COOPER NUCLEAR STATION
DETAILED CONTROL ROOM DESIGN REVIEW
SUPPLEMENT TO THE SUMMARY REPORT

SUMMARY

This report documents Nebraska Public Power District (NPPD) response to the Nuclear Regulatory Commission (NRC) concerns and recommendations resulting from their in-progress audit of the Detailed Control Room Design Review (DCRDR) program at Cooper Nuclear Station (CNS) on November 27-29, 1984, and their review of CNS DCRDR summary report submitted to the staff on February 4, 1985.

PANEL (VBD-S) AS IS

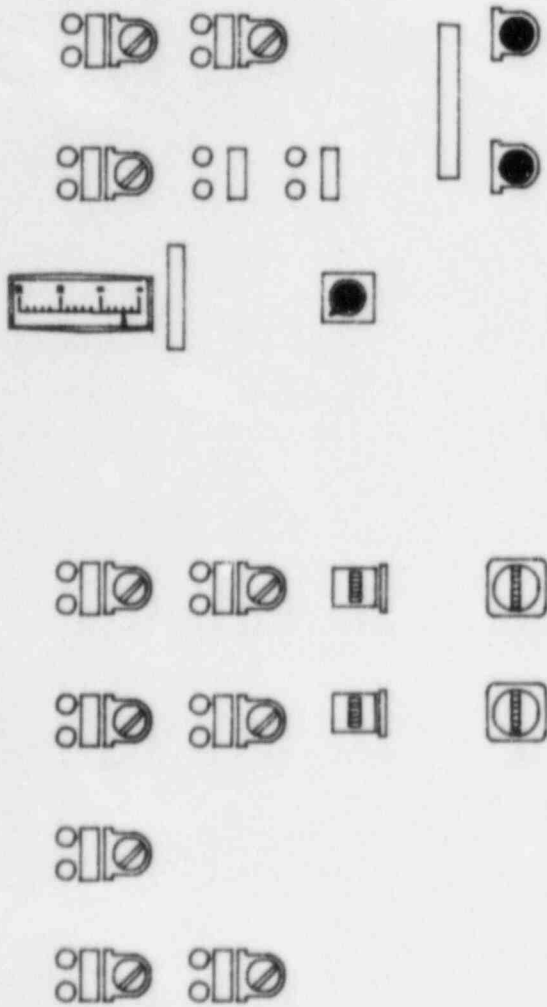
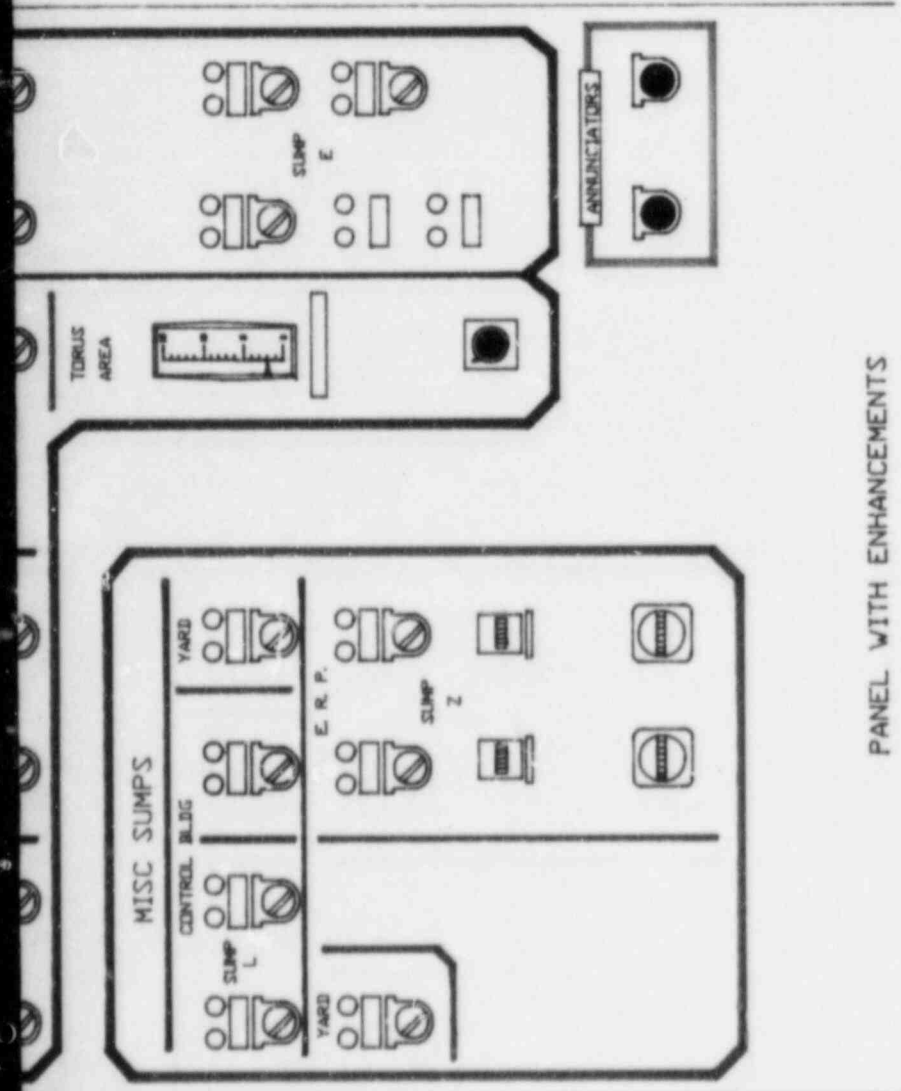
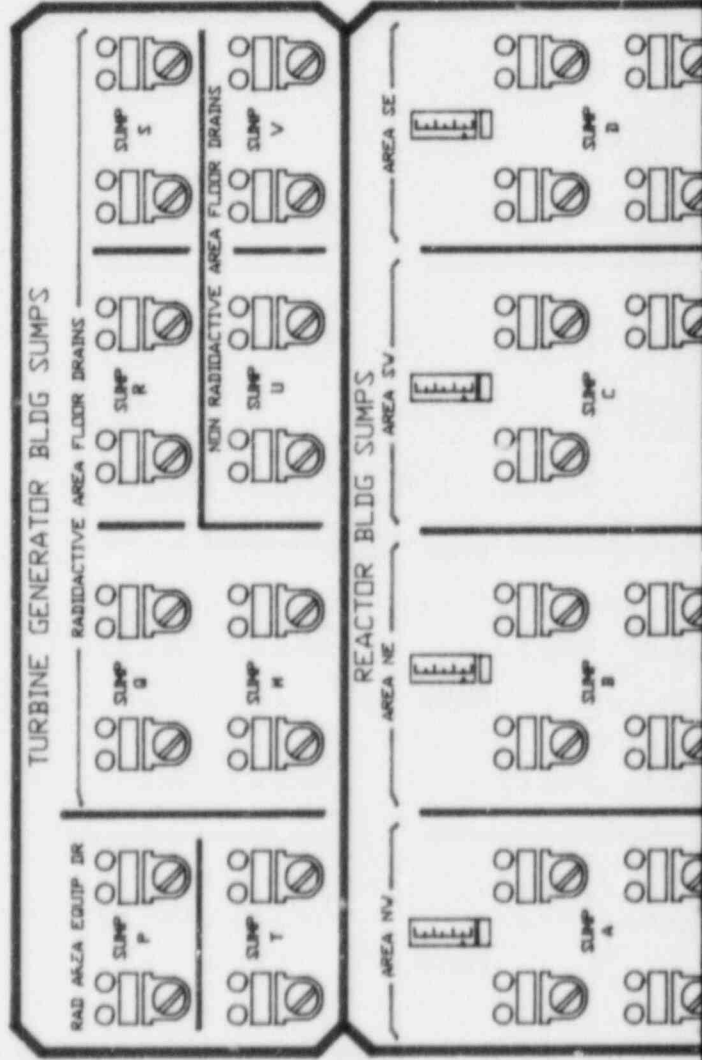
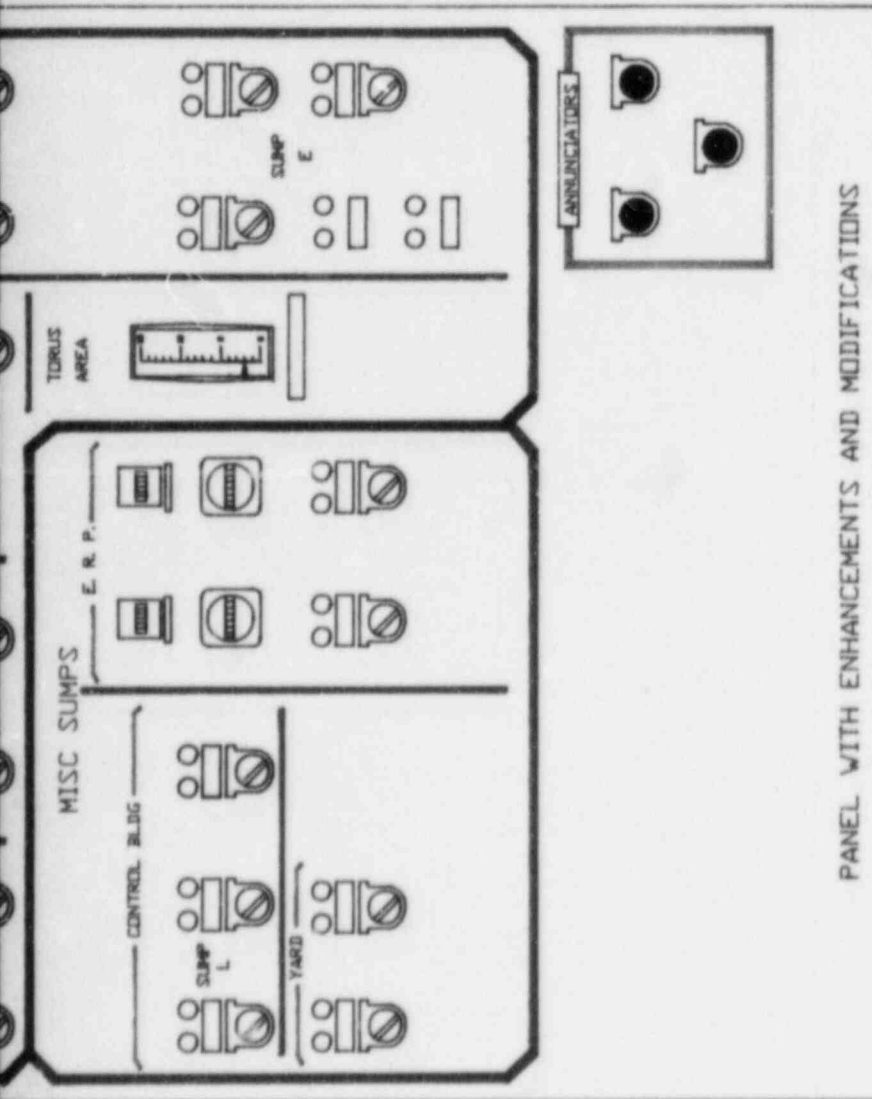
The design improvement process is illustrated in figures 6.2 to 6.8 for the back panels VBD-S, VBD-J and VBD-H, and figures 6.9 and 6.10 for the front panel 9-3. Comparison of figures 6.3 and 6.4 to the As-Is panel drawing of figure 6.2 shows how the enhancements and modifications of tables 6.2 and 6.3 are incorporated in this panel. Similar procedures are being followed with other panels, as noted in Figures 6.5 and 6.6 for VBD-J, and in figures 6.7 and 6.8 for VBD-R. For panel 9-3 where most of the standby core coolant systems (CSCS) instrumentation for the RHR, HPCI, CS and SRVs are located, many controls had to be relocated and new instruments had to be positioned to meet the enhancements and design modifications of tables 6.4 and 6.5 for this panel. Table 6.6 lists the meter and chart recorder enhancements for panel 9-3.

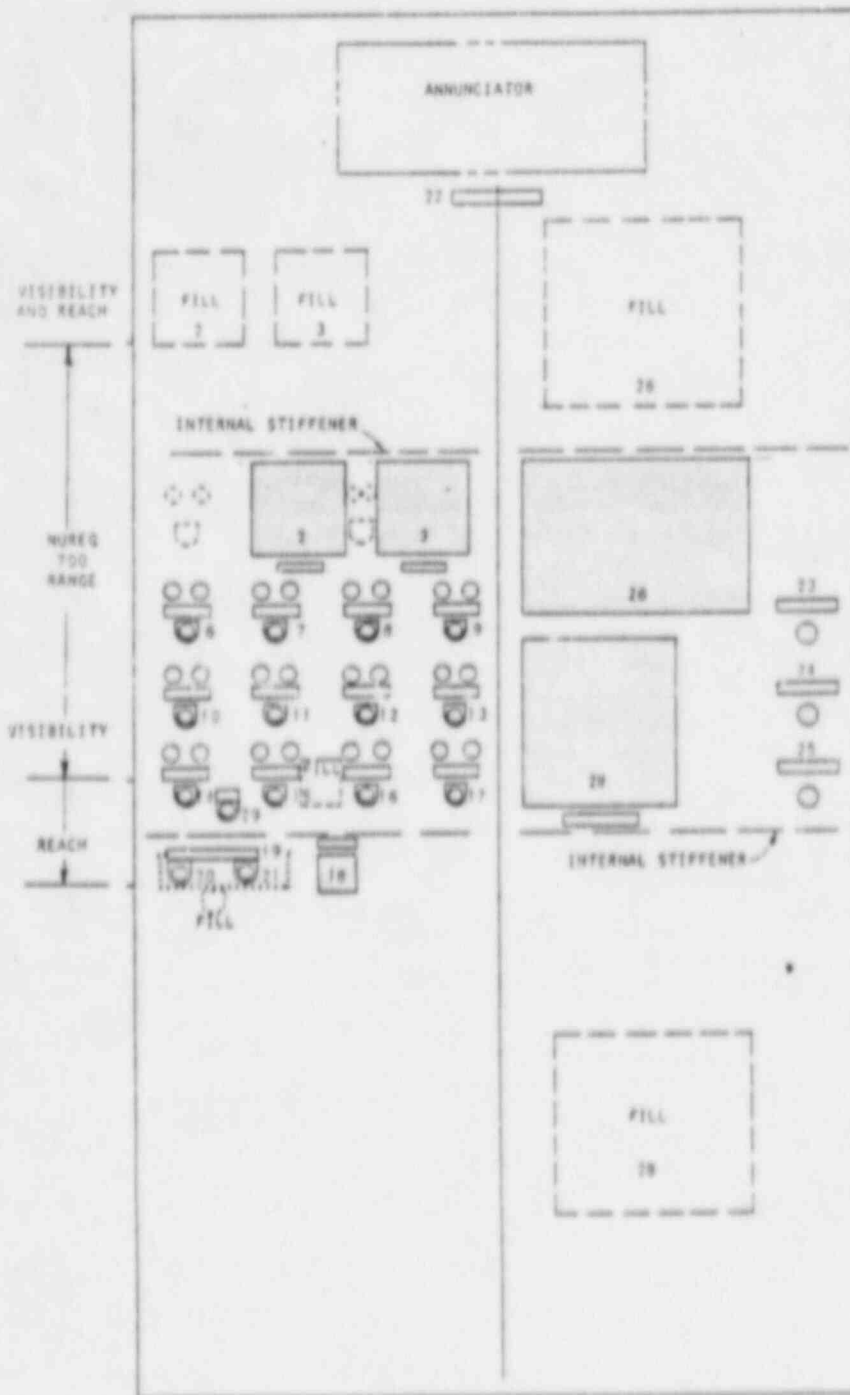
NRC REQUEST: The licensee should complete feasibility studies used to evaluate HEDs relating to Engineered Safety Feature (ESF) Systems information and ESF controls located on back panels; and provide documentation that describes the methodology and procedures used, Reference 12, P.5.

As noted in section 6.1 of this report, the DCRDR team is utilizing the results of the FS report in developing integrated enhancements and modifications for each of the panels, that address the HEDs and meet the station HF standards. Accepting in part or in full the recommendations of the FS report is the responsibility of the DCRDR team, and is decided upon through team evaluation of the severity of the HED, the benefits gained, and of the impact on operator training resulting from the change. Comparison of Figure 6.4 against 6.11 and Figures 6.6 against 6.12 shows how the DCRDR team is incorporating the results of FS in the development of panel enhancements and modifications.
